TO: Derek Case, PE MS 47354 / 360-705-7826
THRU: Paul Johnson, PE NB82-230 / 206-805-2920
FROM: Andrew P. Walter, PE NB82-230 / 206-805-5452
SUBJECT: 007999 – SR99 Bored Tunnel Alternative Design-Build Project
Federal-Aid No. BR-NH-STP-STPF-0099(111)
CO 203 R1 – PCO 640, SURFACE TEXTURING

Attached for HQ execution is Change Order 203 R1, "PCO 640, SURFACE TEXTURING".

CONTRACT NO: 007999 FEDERAL AID NO: STP-BR-IM-0099 (11)
CONTRACT TITLE: SR 99, BORED TUNNEL ALTERNATIVE - DESIGN BUILD PRO
CHANGE ORDER NO: 203 RI PCO 640, SURFACE TEXTURING

Subject: SR 99 Bored Tunnel Alternative Design-Build Project
Contract No. 007999 / Federal-Aid No. BR-NH-STP-STPF-0099(111)
Request for Change Proposal – Roadway Surface Abrasion

SR 99 TUNNEL PROJECT CONTRACT PACKAGE 14	PM100
PAVEMENT MARKING AND BARRIER PLANS - SB

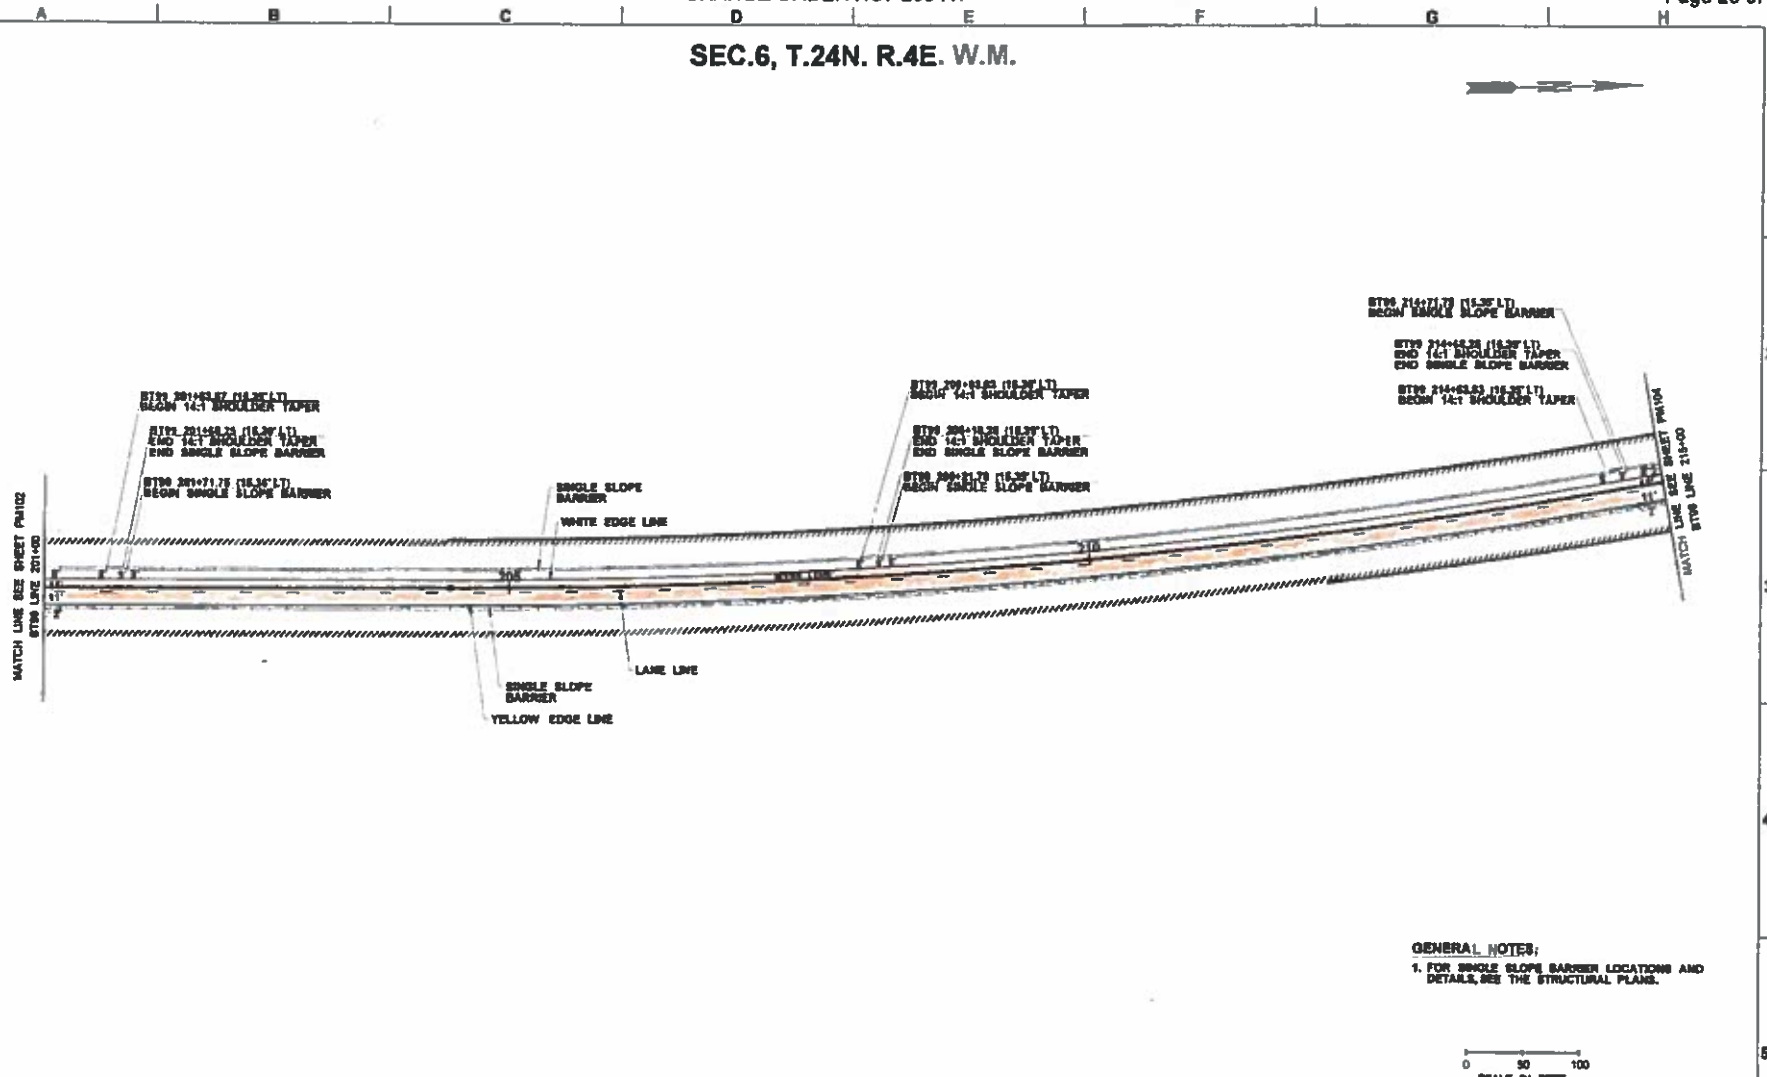
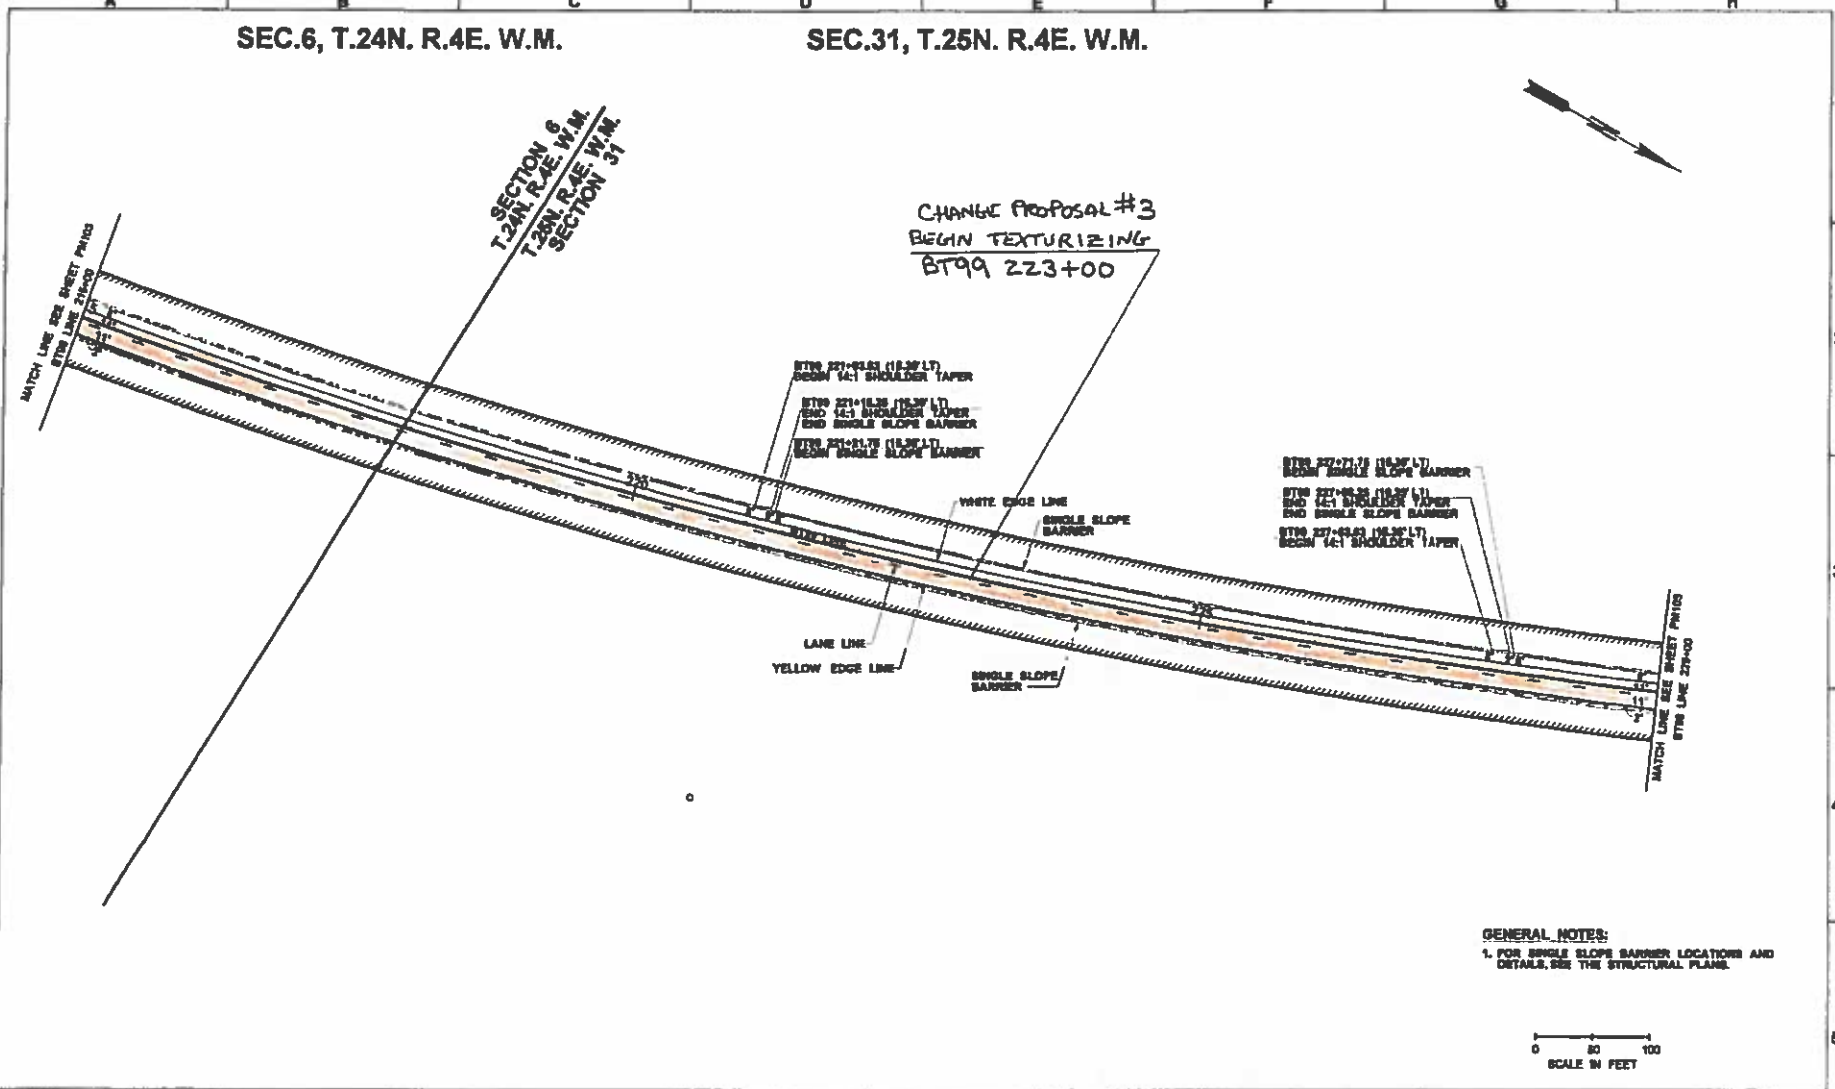
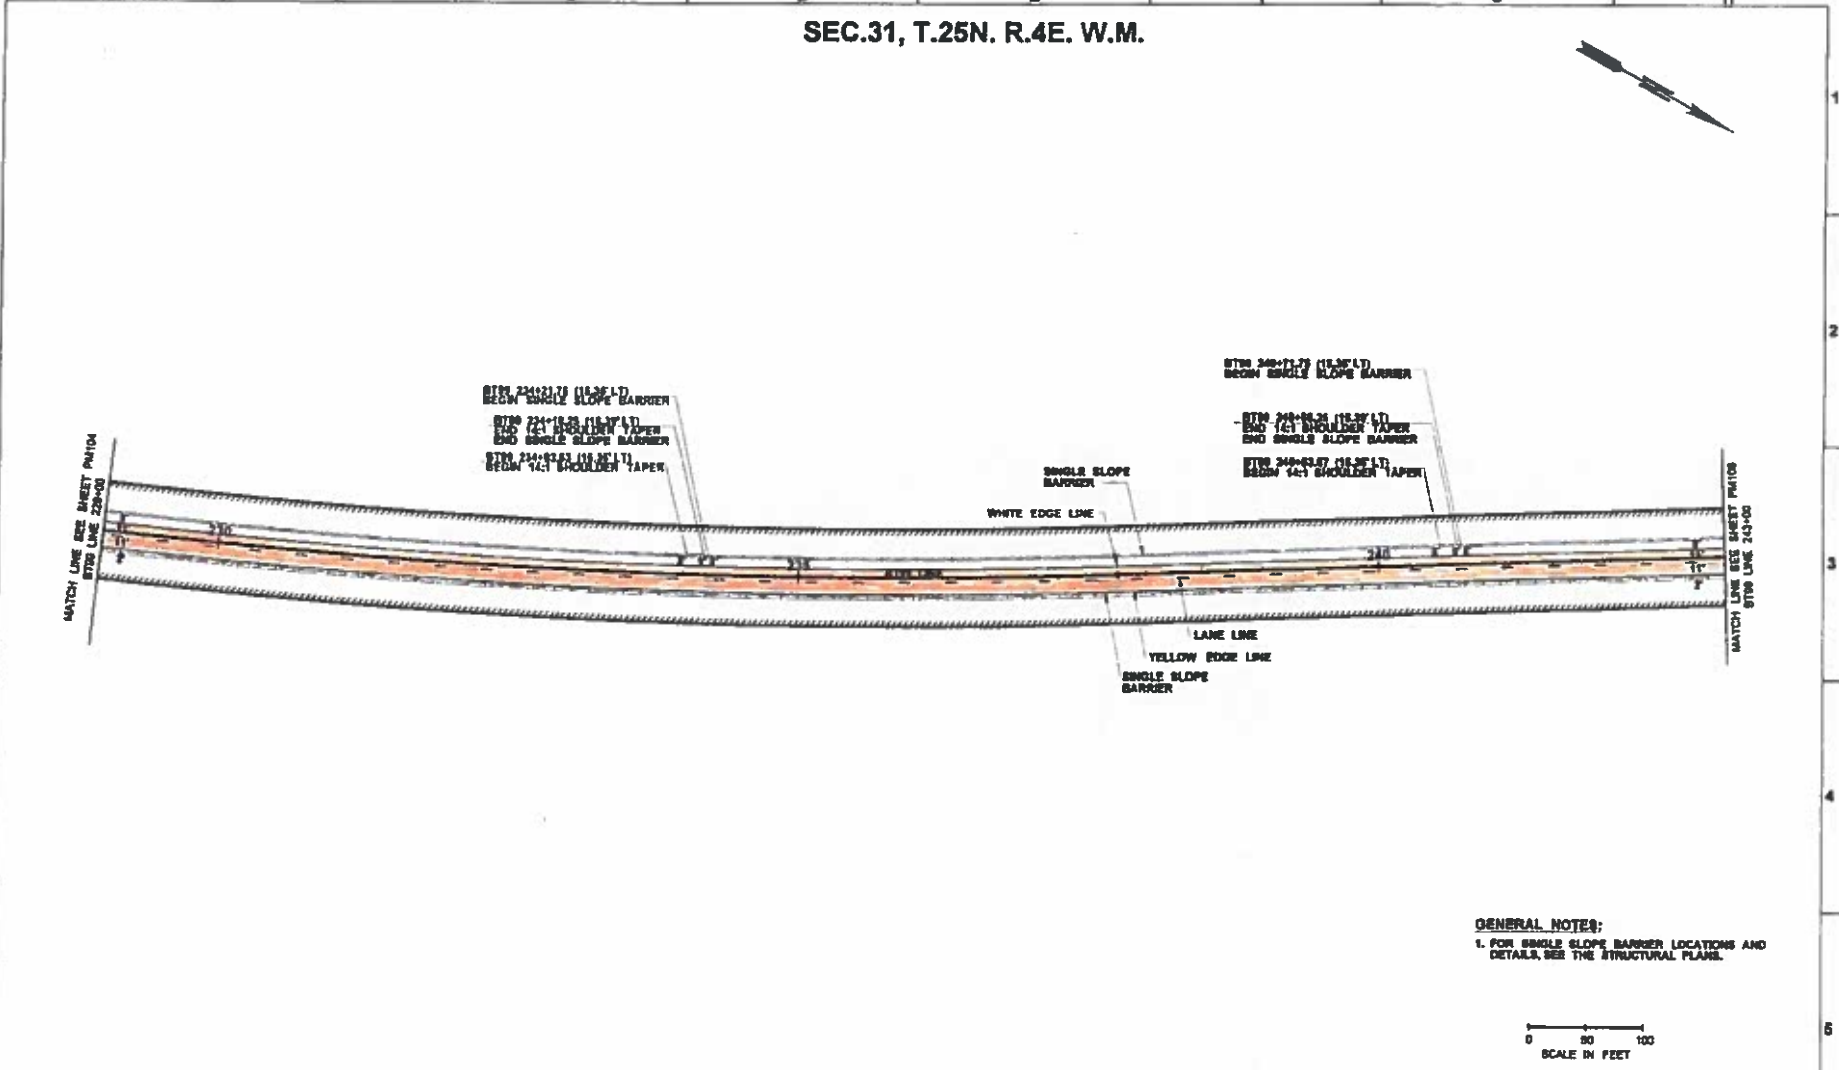
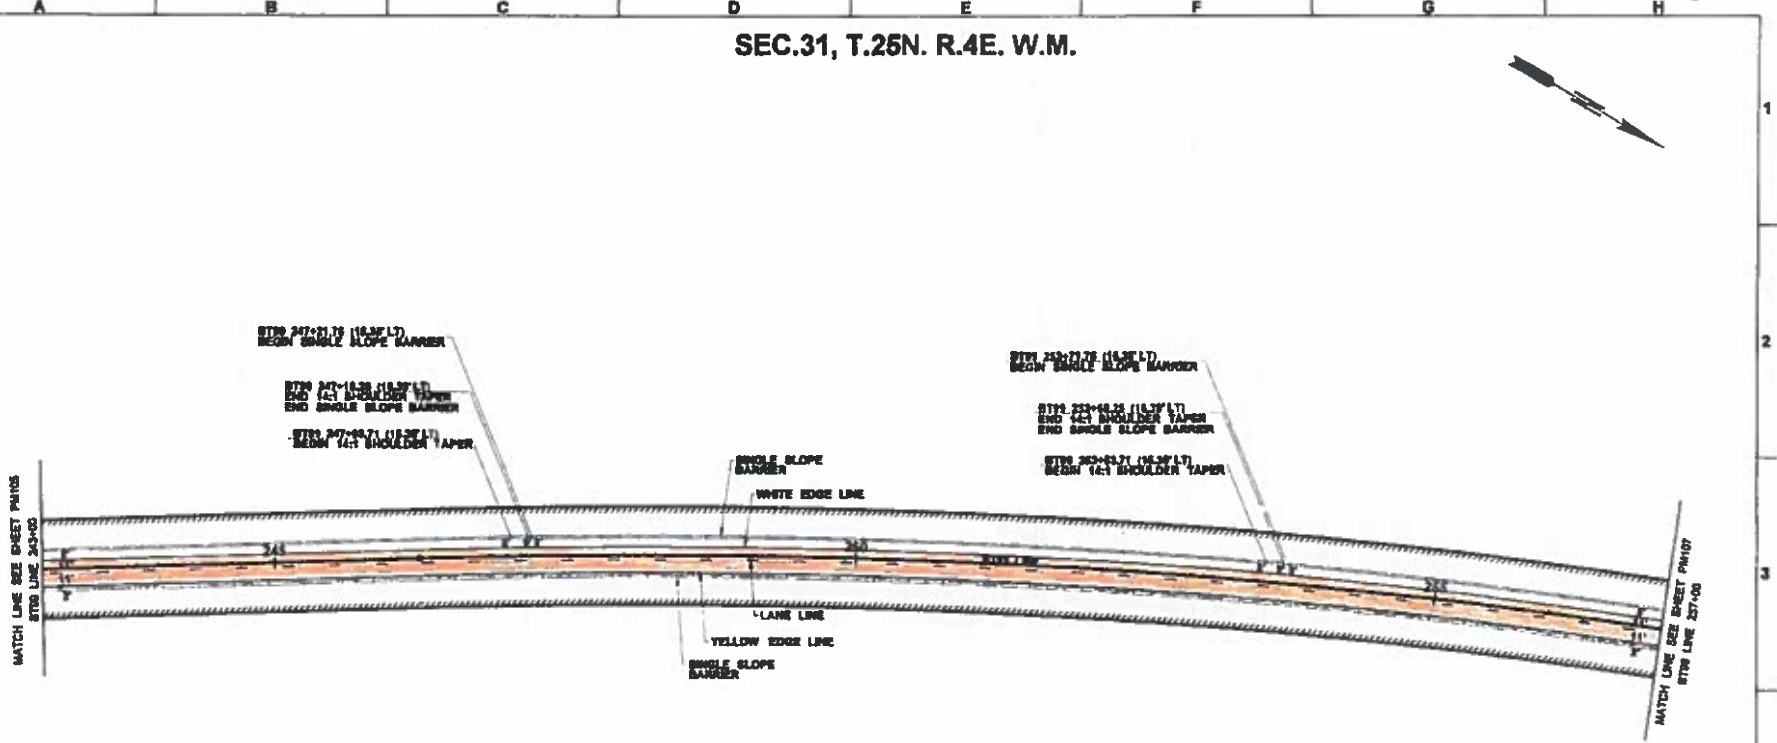
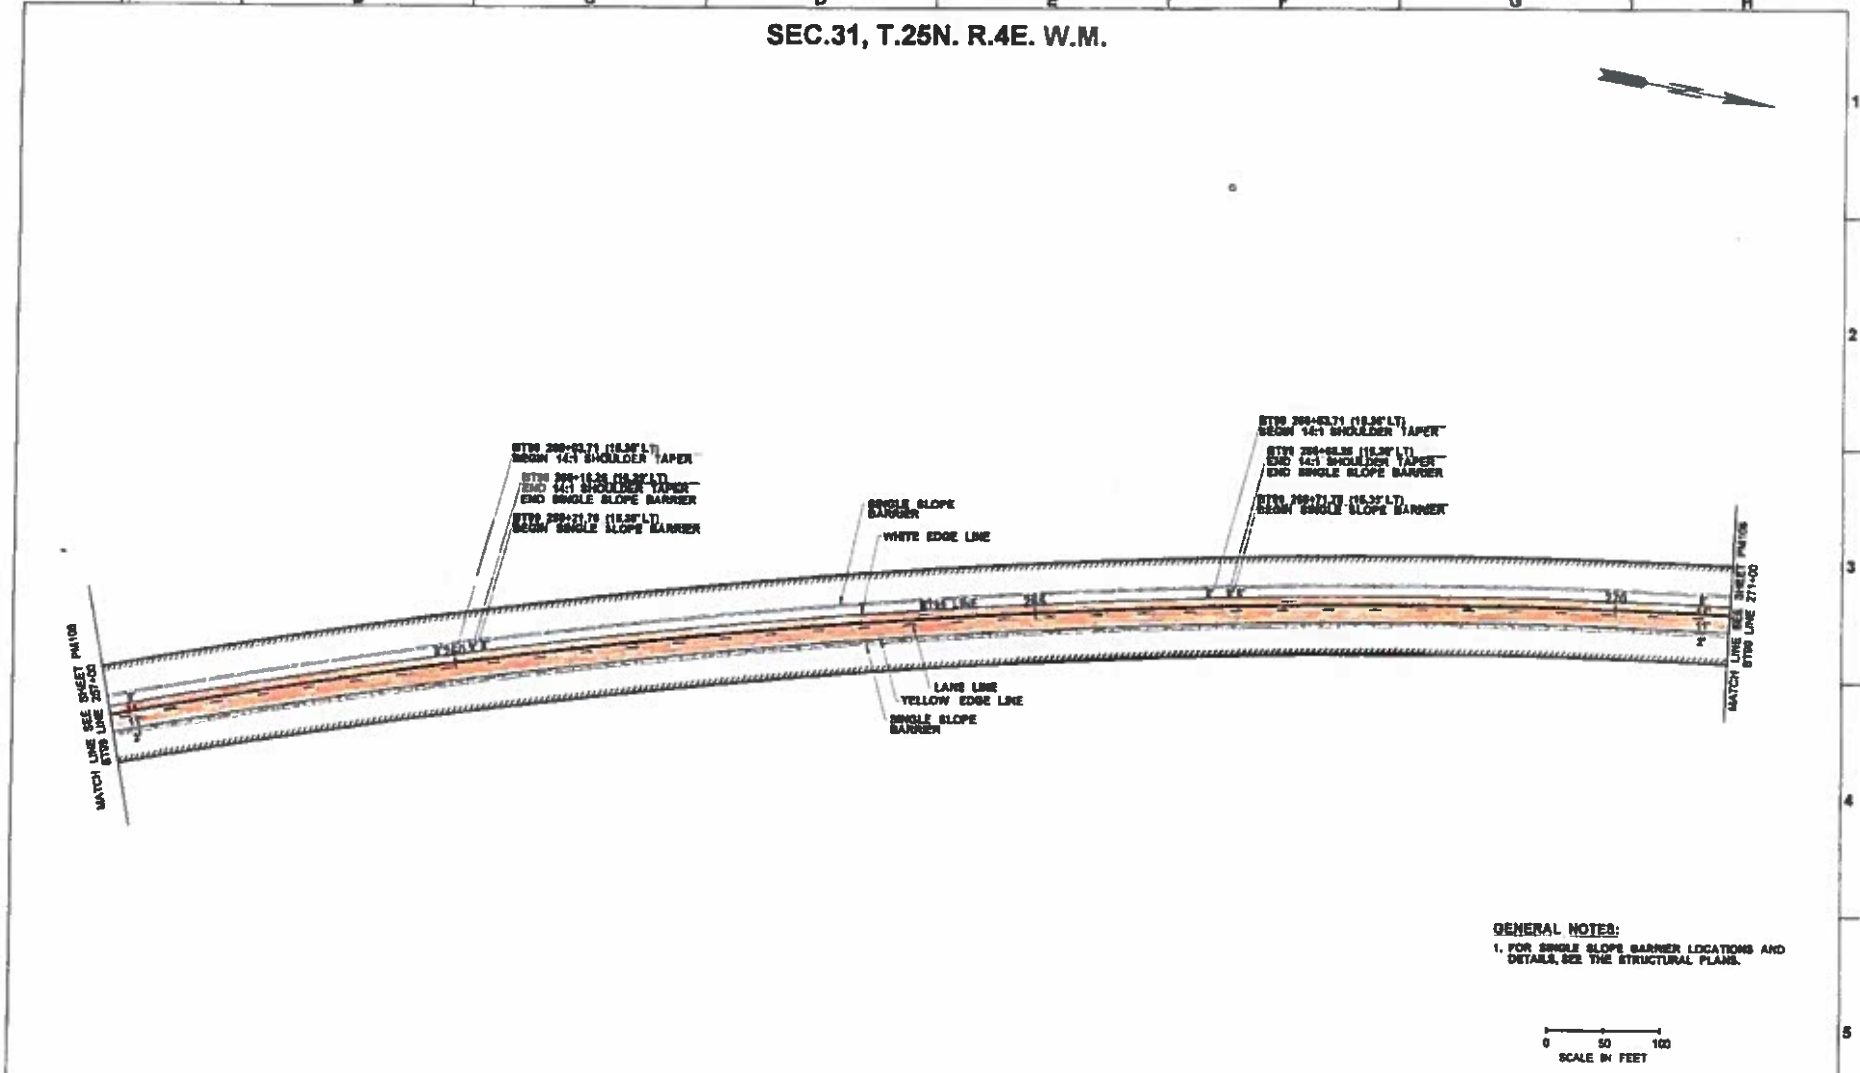
- NBOFF 304+50 to 304+63.89
- Texturize two 11-foot lanes, southbound tunnel, portal to portal, stations:
 - S-SB99 191+58.85 to S-SB 194+58.84 (match line with BT99 194+50)

- Southbound roadway BT99 194+50 to BT99 287+23.14 (match line with N-SB99 299+99.99)
 - N-SB99 299+99.99 to N-SB99 304+70
 - N-SB99 300+00, begin ramp taper to N-SB99 303+00 end ramp taper

- N-SB99 303+00 to N-SB99 304+70, 23' wide right lane
- Also texturize the 8-foot shoulder, both northbound and southbound (it is acceptable to limit texturing to 6-feet on shoulder)
